APPLICATION NO.	FILING DATE	FIRST NAMED INVENTOR	ATTORNEY DOCKET NO.	CONFIRMATION NO.
10/780,329	02/17/2004	Jeff Grady	4185-101-CIP2	1103

Advisory Action Before the Filing of an Appeal Brief	Application No.	Applicant(s)	
	10/780,329	GRADY, JEFF	
	Examiner	Art Unit	
	Nguyen T. Vo	2618

AUDIO PLAYER ASSEMBLY COMPRISING AN MP3 PLAYER
Applicant: Jeff Grady. Serial No. 10/780,329 Attorney Docket: 4185-101 CIP2
REPLACEMENT SHEET

Figure 1

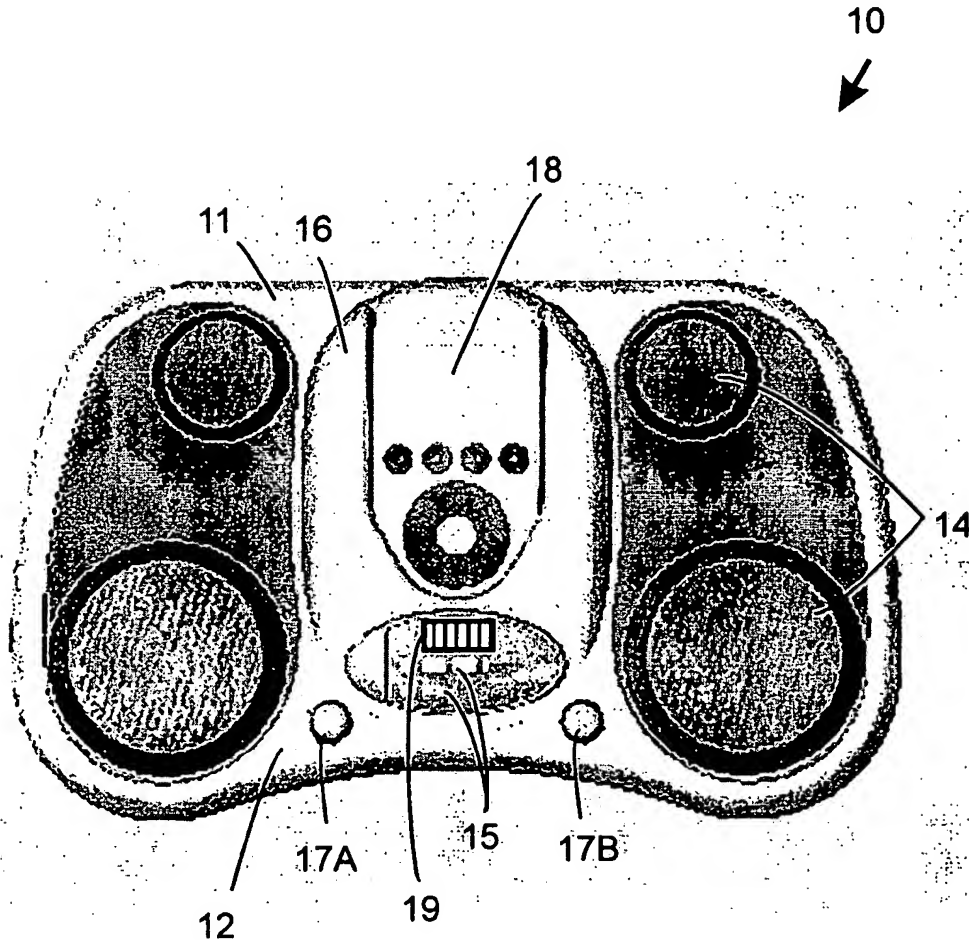
The drawings were received on December 4th, 2006. These drawings are not approved because it raises the issue of new matter. More specifically, the original specification discloses that the docking unit 16 comprises a frequency tuning control (see original claim 13). However, amended figures 1-3 show **two** frequency tuning control 17A and 17B, and these two frequency control are located outside of the docking unit 16.

figures 1, 2, 3 are
NOT approved.
nVo
1-8-2007

Figure 2

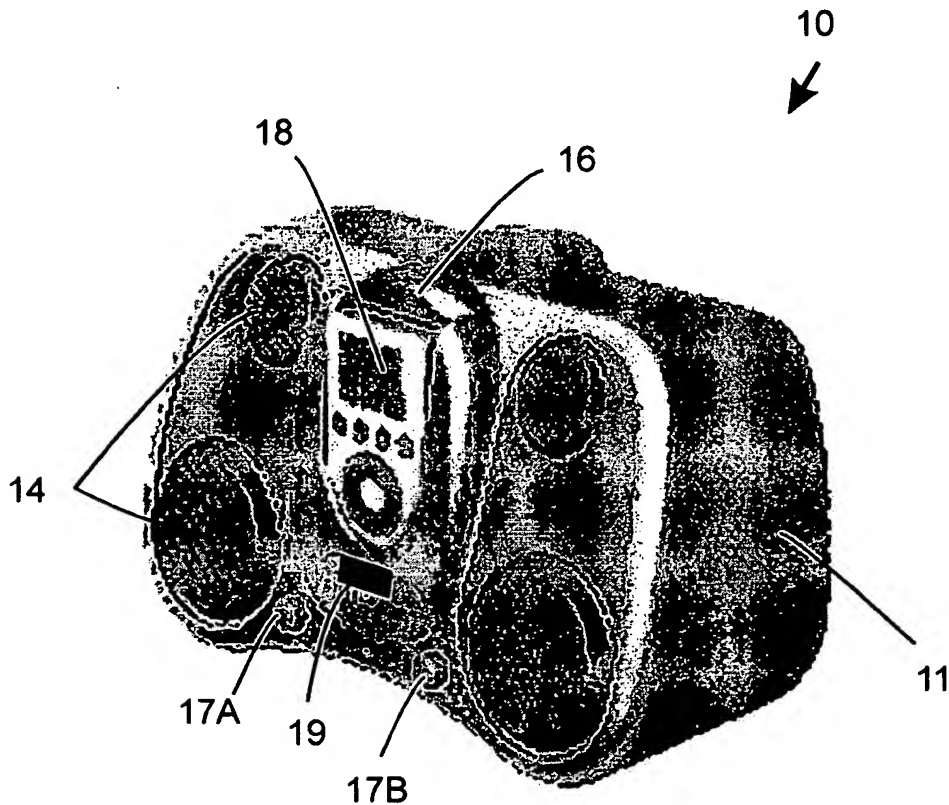
figures 1, 2, 3 are
NOT approved
nVo
1-8-2007

Figure 3

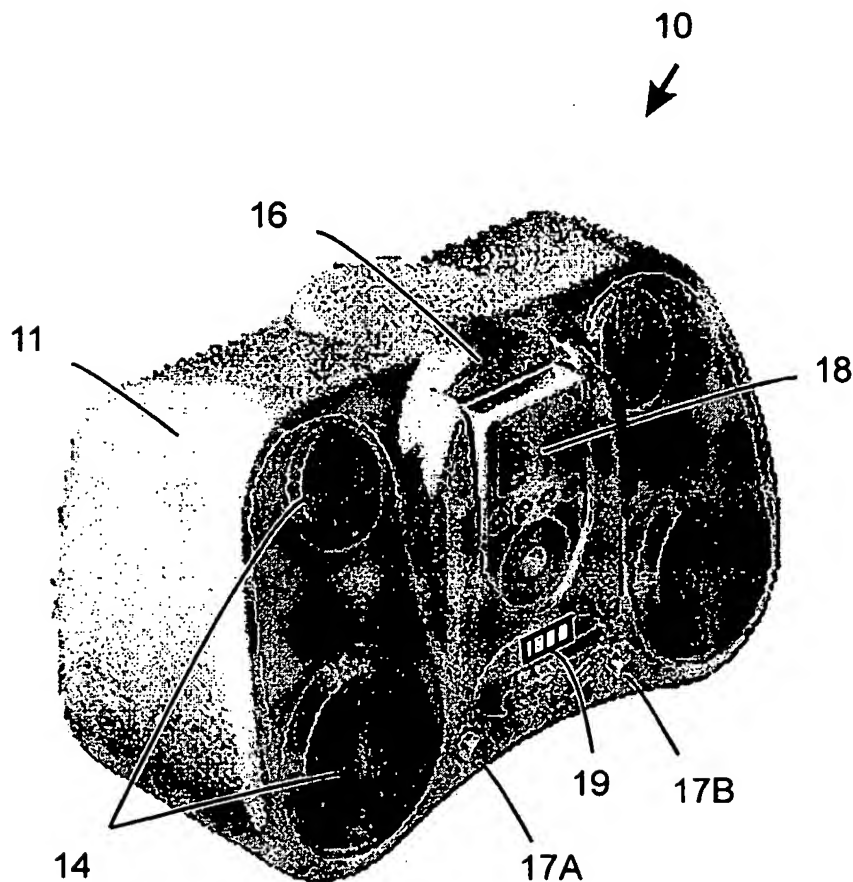
figures 1, 2, 3 are NOT
approved
nVo
1-8-2007
